Title - Sujet Air Handler/Manifold Replacement	
Solicitation No. - N° de l'invitation 39903-180402/A	Amendment No. - N° modif. 004
Client Reference No. - N° de référence du client 39903-180402	Date 2017-10-05
GETS Reference No. - N° de référence de SEAG PW-\$PWY-025-8166	
File No. - N° de dossier PWY-7-40174 (025)	CCC No./N° CCC - FMS No./N° VME
Solicitation Closes - L'invitation prend fin at - à 02:00 PM on - le 2017-10-17	Time Zone Fuseau horaire Pacific Daylight Saving Time PDT
F.O.B. - F.A.B. Plant-Usine: <input type="checkbox"/> Destination: <input checked="" type="checkbox"/> Other-Autre: <input type="checkbox"/>	
Address Enquiries to: - Adresser toutes questions à: Fung, Donna(PWY)	Buyer Id - Id de l'acheteur pwy025
Telephone No. - N° de téléphone (604) 671-9689 ()	FAX No. - N° de FAX (604) 775-6633
Destination - of Goods, Services, and Construction: Destination - des biens, services et construction: CFIA - Burnaby Lab - Burnaby, BC

ADDENDUM #3

CANADIAN FOOD INSPECTION AGENCY
AHU REPLACEMENT/EXHAUST MANIFOLD
BURBABY BC
Project No: R.39903-180402

**PARTIAL A04 - CRAWL SPACE
NEW PLAN**

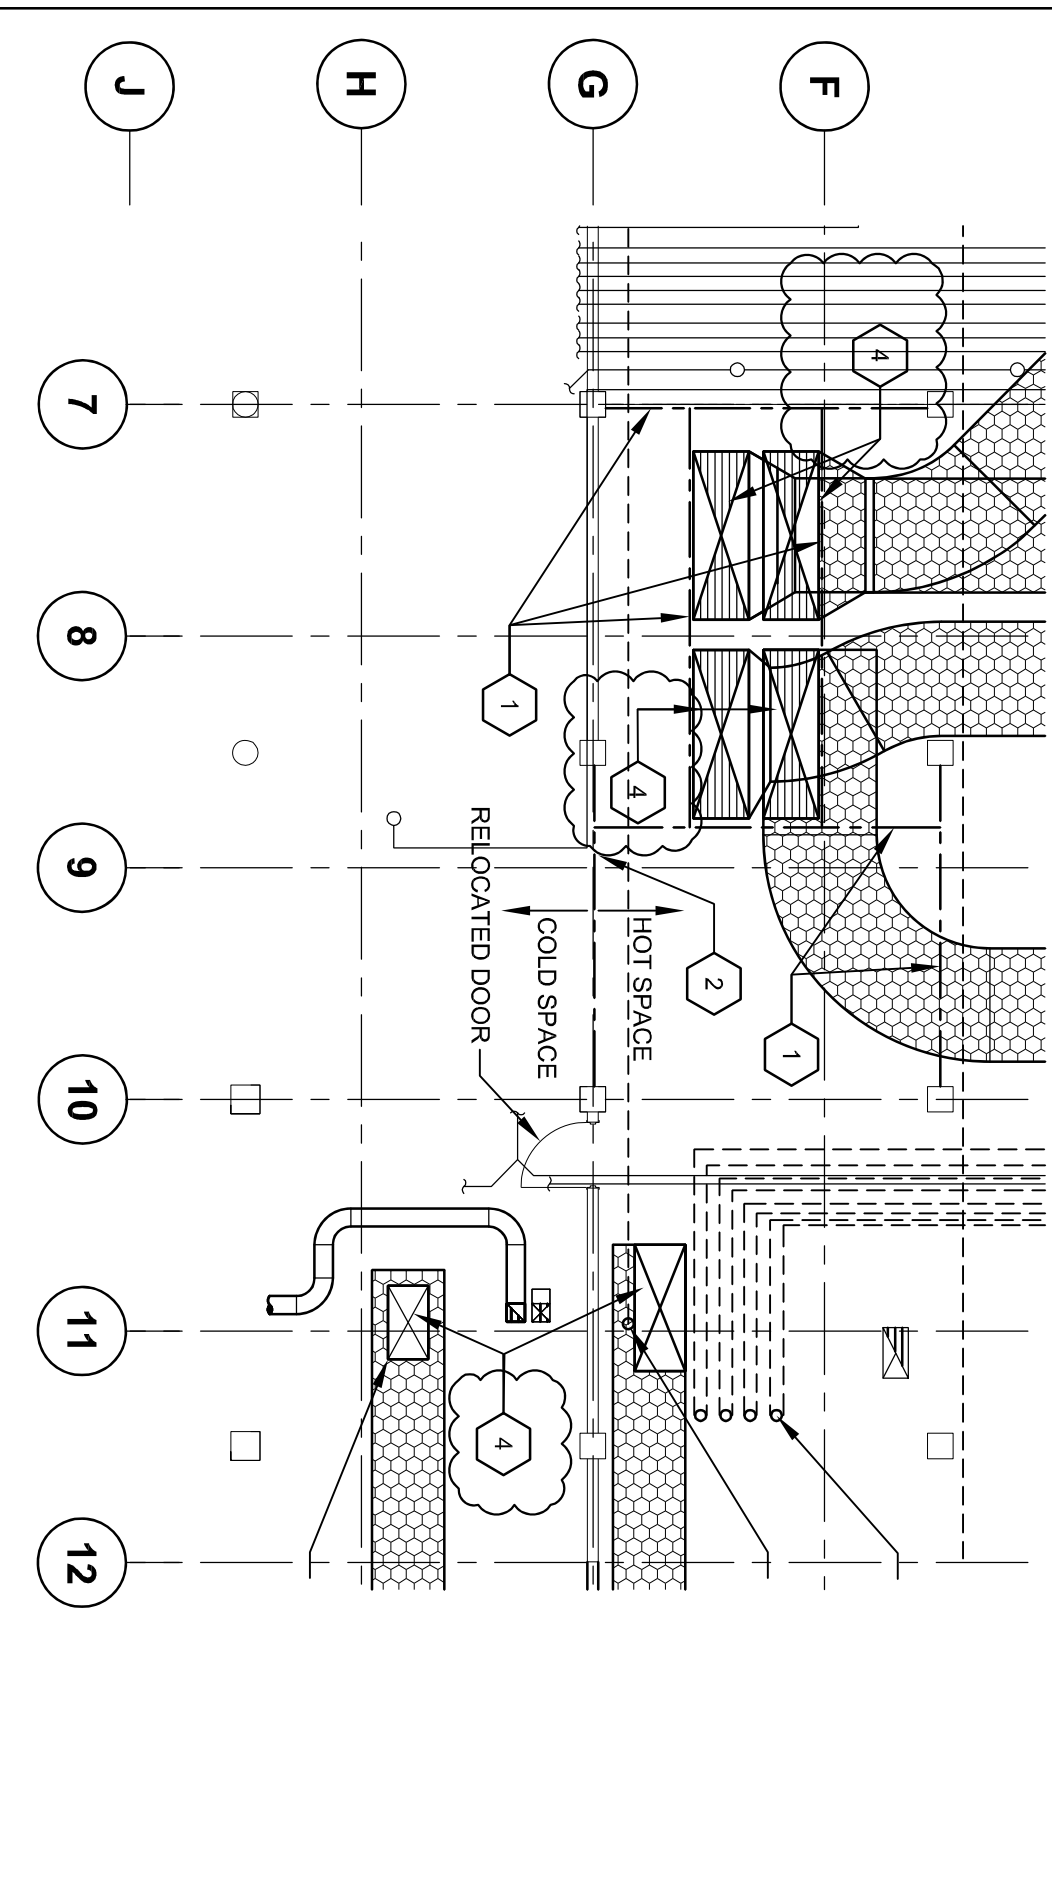
1. Revise PARTIAL A04 – CRAWL SPACE NEW PLAN as per attached AD-01.
